DRAFT ENVIRONMENTAL IMPACT STATEMENT

SHU'LUUK WIND PROJECT

COMMENTS - WATER ISSUES

Victor M. Ponce

Fig. 3 Delineation of study subbasin (in burgundy), Golden Acorn Casino (light blue), and Campo Materials (light blue), within the Campo Indian reservation (in dark gray) (AECOM, 2012b).

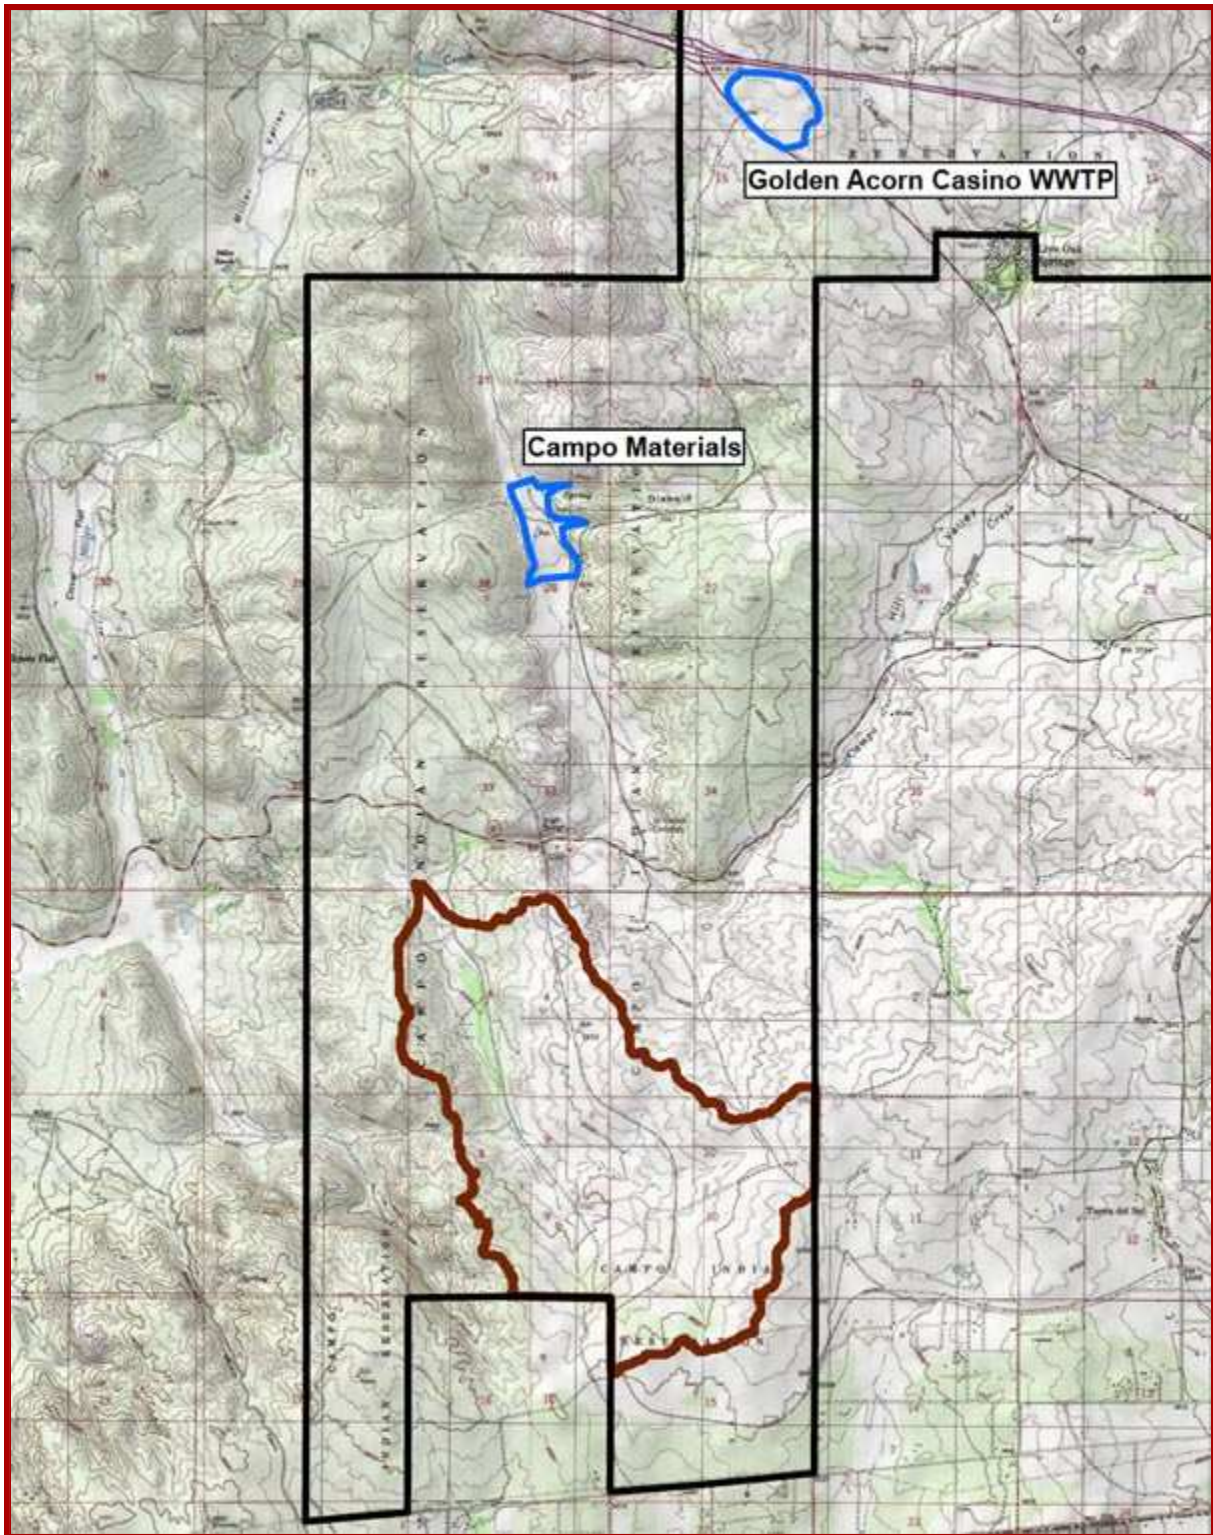
1. Local groundwater from two (2) production wells located in the southeastern portion of the reservation, with a total of 70,000 gpd. For this purpose, a study subbasin (tributary of Campo Creek) encompassing the two production wells has been identified (Fig. 3). This subbasin, delineated in burgundy color, has a drainage area of 1,691 acres;
2. Treated wastewater from the Golden Acorn Casino wastewater treatment plant, labeled as WWTP and delineated in light blue in Fig. 1, with a total of 150,000 to 300,000 gpd, subject to an appropriate check on the quality of the effluent;
3. Water purchased from Campo Materials (Fig. 3); and
4. Off-reservation sources.

According to the DEIS, as much as 50% of the water needed during the first three months would need to be supplied by alternative sources, including Golden Acorn casino, Campo Materials, and off-

reservation sources (AECOM 2012b). A detailed analysis of alternative sources of water, including type, origin, quantity and quality, is missing from the DEIS.

Fig. 5 Annual precipitation in Campo, California (1949-2012).¹

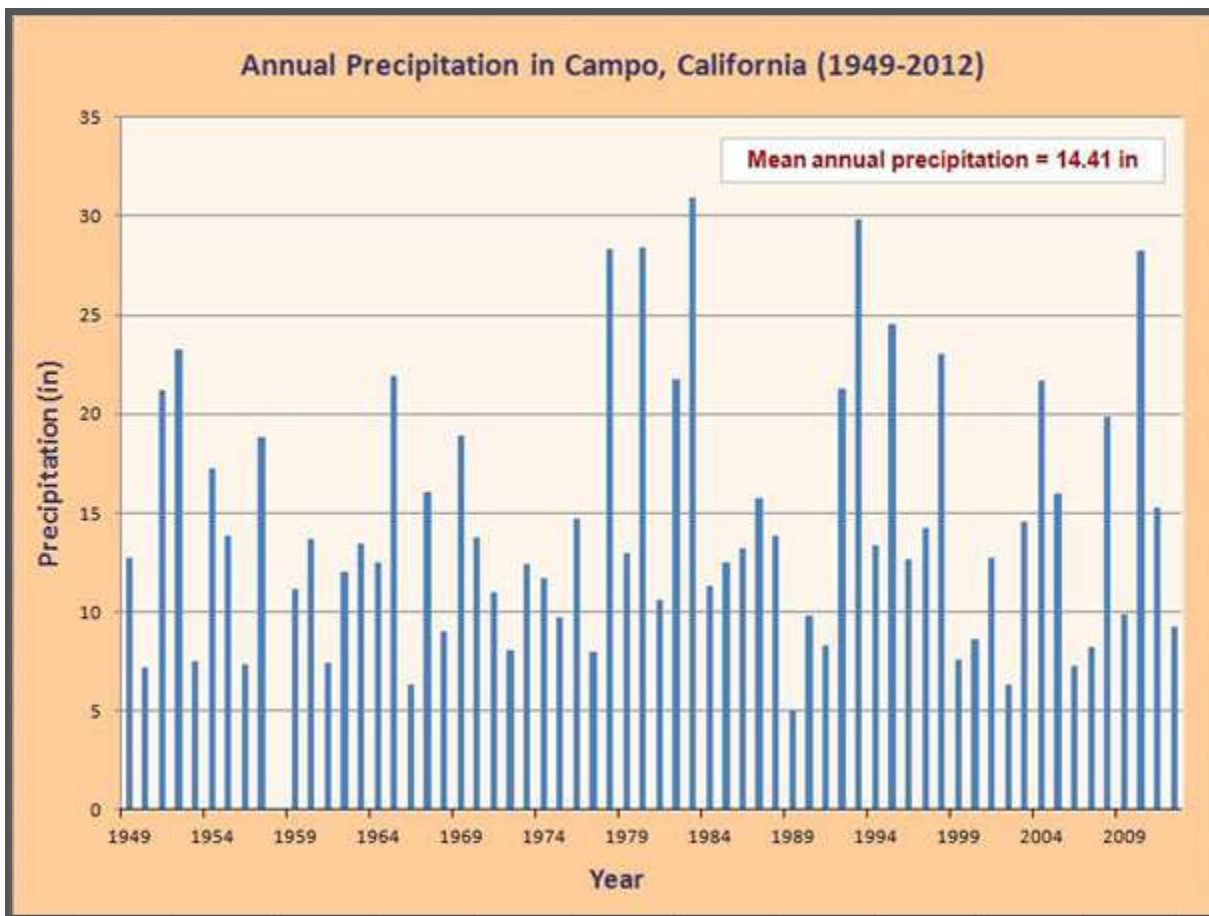
The study area has been estimated to be in the rainfall belt of 15-18 in of mean annual precipitation (AECOM 2012b). In this document, the mean annual precipitation was calculated based on the existing record for the Campo gage, spanning the period 1949 to 2012. The record of annual precipitation is shown in Fig. 5. The mean annual precipitation for the period of record is 14.41 in.² Annual precipitation at the Campo gage has varied from a low of 5.07 inches in 1989 to a high of 30.94 inches in 1983.

For instance, Scanlon *et al.* (2006) have performed a global synthesis of groundwater recharge in semiarid and arid regions, using approximately 140 study areas, including the U.S. Southwest. They report values of recharge varying between 0.1% and 5.0% of mean annual precipitation. Thus, the value of recharge calculated in the DEIS (1.37 in, amounting to 9.5% of precipitation) appears to be too high. An updated calculation is needed.

Fig. 6 Geologic fractures identified in the vicinity of the Shu'luuk Wind project site (Ponce 2006).

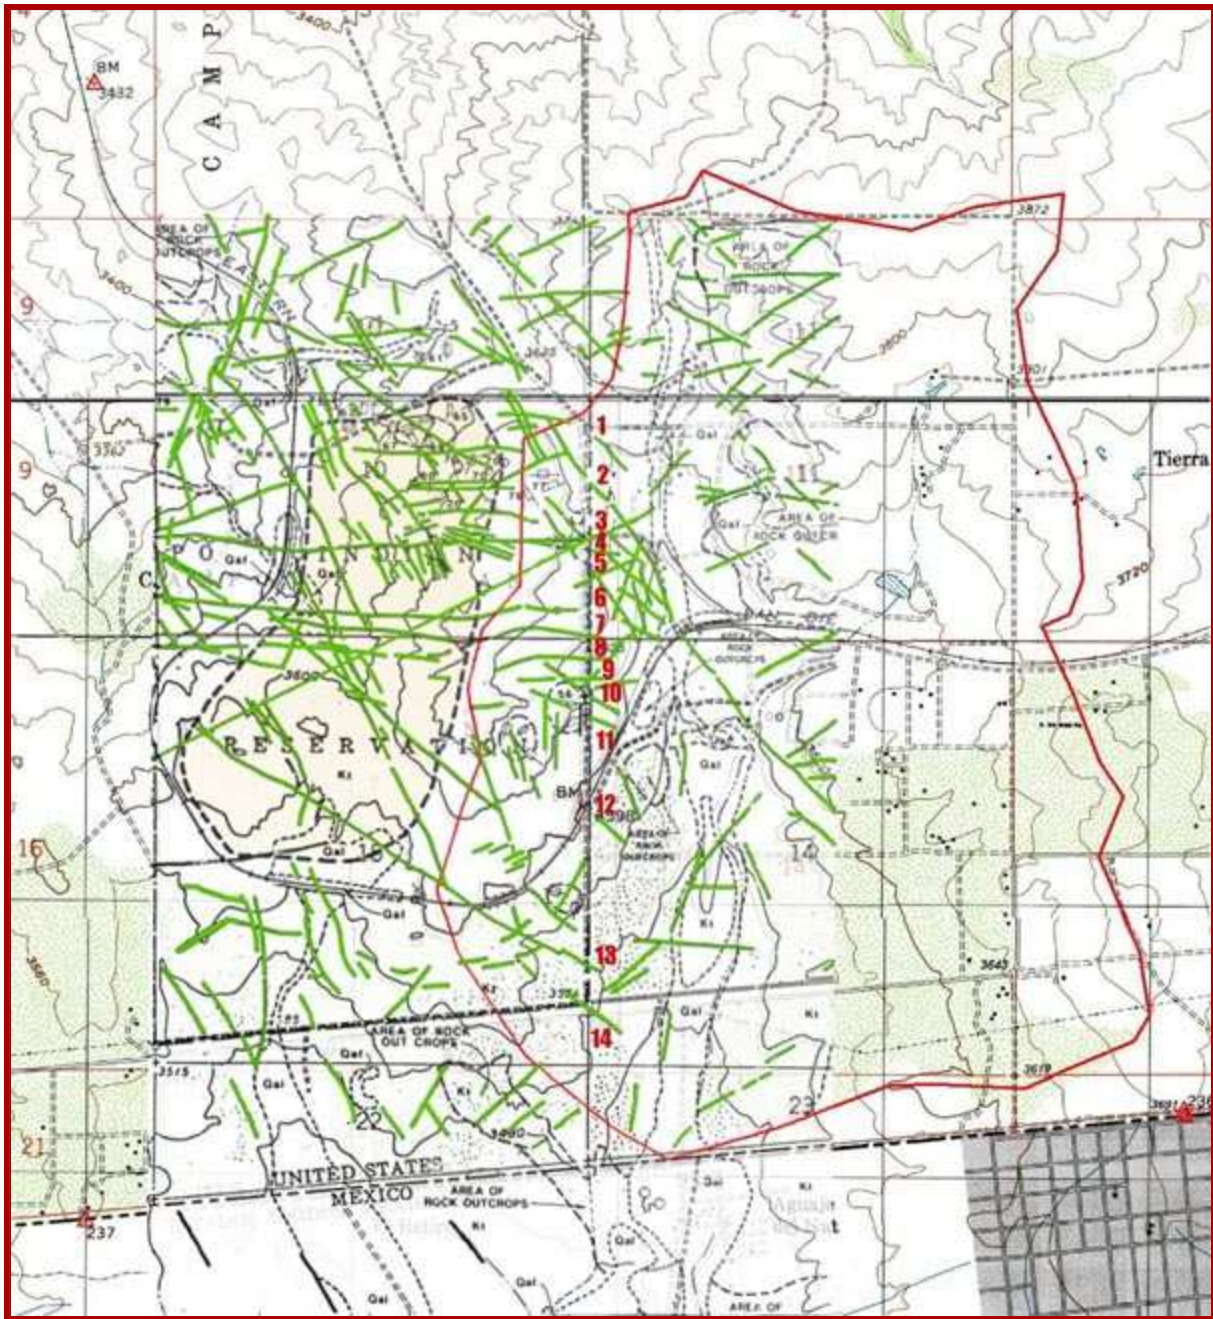
Many of the identified fracture alignments cross the landfill site in a predominantly west-east direction. At least fourteen (14) fracture alignments cross the boundary between the Campo Indian reservation and privately owned land immediately east of it (Fig. 6). The DEIS lacks an updated assessment as to the extent of these fracture systems and their effect on the groundwater flow patterns. In addition, the potential for off-site impacts to existing wells, springs, seeps, and riparian vegetation are not adequately addressed in the DEIS (AECOM 2012b).

Fig. 8 Other projects planned in the vicinity of Shu'luuk Wind Project
[\(Click to enlarge\)](#).

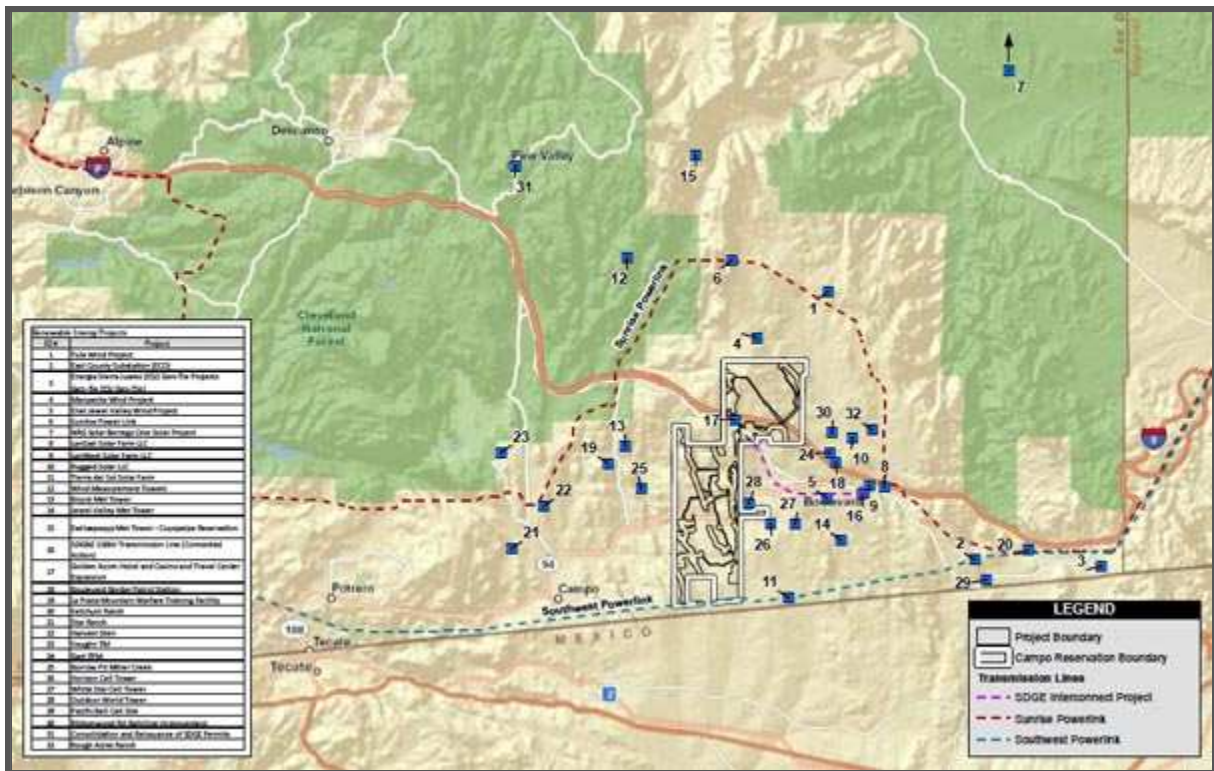
The Shu'luuk Wind project is one of several [alternative] energy projects being planned in the San Diego backcountry, in and around the community of Boulevard (Fig. 8) (AECOM 2012a). The aggregate impact of all these projects to the natural, aesthetic, and other resources of these rural communities has not been fully addressed. Many of these projects will require substantial amounts of water which, if obtained onsite or from local water districts, will have to tap the underlying aquifer. A partial list of these projects and their estimated water demands is shown in Table 6.

The Shu'luuk Wind Project plans to pump groundwater from two wells located within the reservation limits (Table 4). Possible well interference with other wells, both inside and outside the reservation, is not addressed in the DEIS. Well pumping, together with that of other wells to be used for other projects in the vicinity, is likely to tax the local aquifer beyond its sustainable yield (Section 4.2).

Fig. 10 Tierra del Sol watershed, draining into Aguaje del Nat, near the community of Jardines del Rincón, immediately south of the U.S.-Mexico border (Ponce 2006).

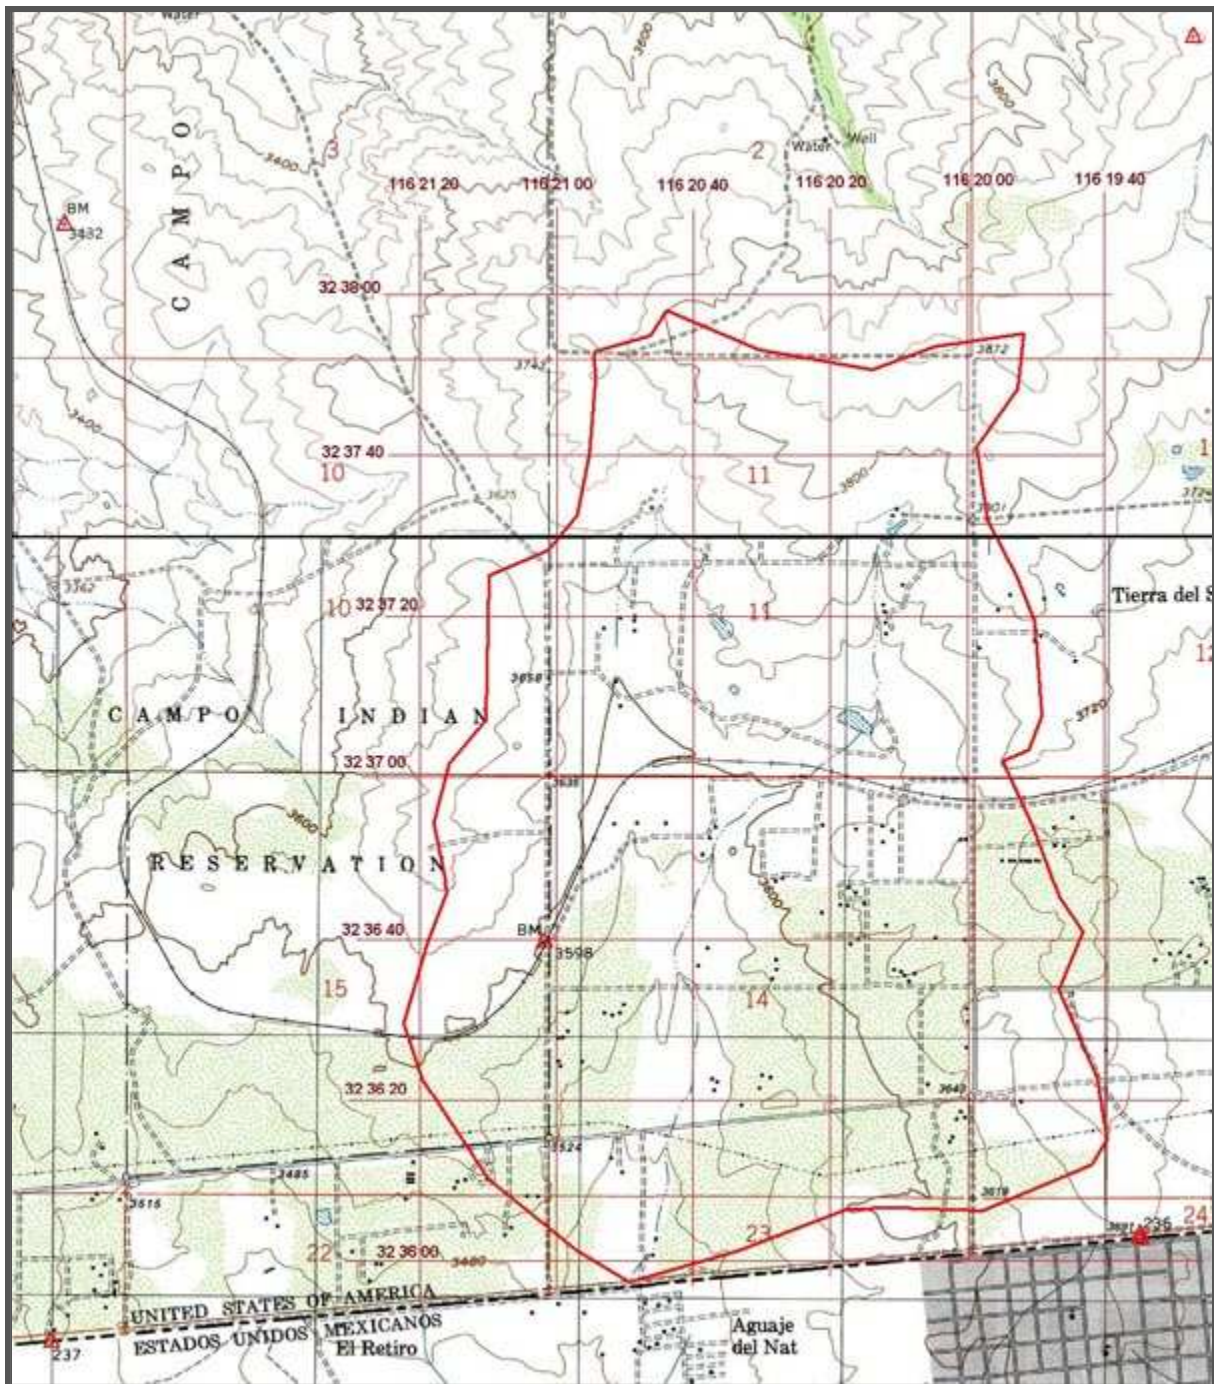
The DEIS does not state explicitly the possible transboundary surface and groundwater impacts of the project and their mitigation. Yet the distance from the Shu'luuk Wind Project to the U.S.-Mexico border is actually less than one mile (AECOM 2012a).

In particular, the 40 MW solar project footprint (Alternative 2) will lie partially within the Tierra del Sol watershed (Fig. 10) (Ponce 2006). Underlying water-bearing fractures, documented in Fig. 6, help redirect the flow toward the Tierra del Sol aquifer. The Tierra del Sol watershed and its aquifer drain south into Mexico through Aguaje del Nat, about 0.6 miles west of the community of Jardines del Rincón. The latter is the shaded gray area at bottom right of Fig. 10. The flow at Aguaje del Nat has been estimated at 8 gpm in April 2010 (Ponce 2010).
